Title: Observing glacier elevation changes from spaceborne optical and radar sensors – an inter-comparison experiment using ASTER and TanDEM-X data

Author(s): Livia Piermattei et al.
MS No.: egusphere-2023-2309
MS type: Research article

Author’s response related to the comments received to the manuscript:
<https://doi.org/10.5194/egusphere-2023-2309>

“Figure 4: ... Sankey produced with Sankeymatic (SankeyMatic, 2023). At the bottom is the list of the participants in each group with their main institution.”

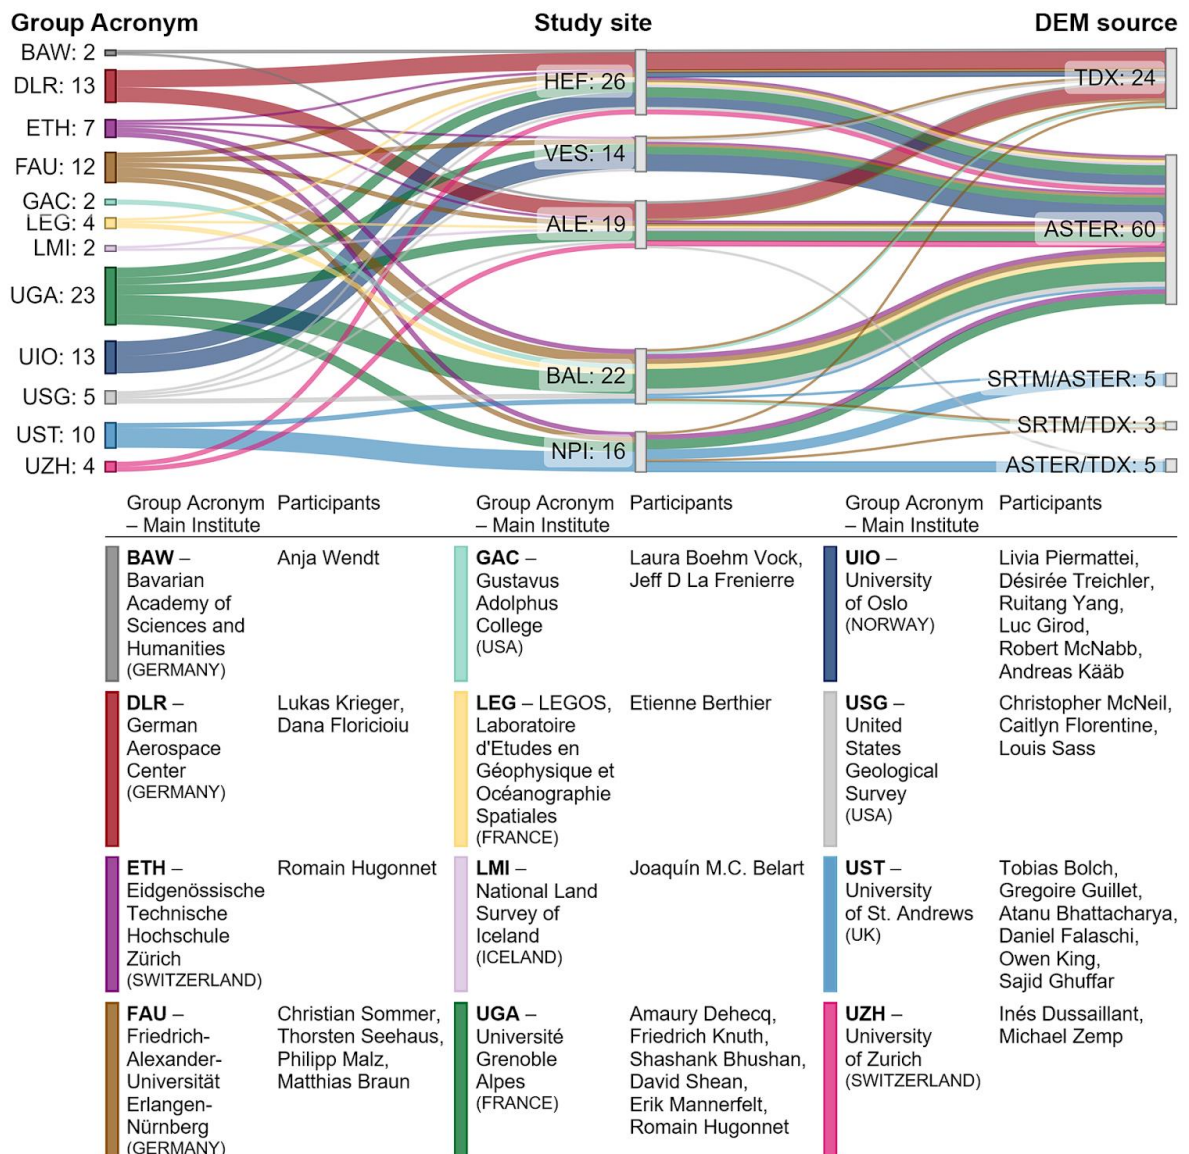
Figure 4 and section 3.x.x.x. – I wonder if there is a better way to show all 12 groups in the figure and in text. Readers have to refer to Supplement to know more about the groups and the members, which sometimes can be annoying. Can you provide a table in the manuscript referring to these members and groups. I know it will be cluttered but atleast useful not to check multiple documents at the same time. Think about it!

Response: We think that the Sankey diagram clearly shows how the study sites and DEM sources are connected to different groups. However, we agree that making the group members more visible is important. To address this, we included a table in Figure 4 that lists the names of the participants in each group with their main institution. Thank you for this suggestion.
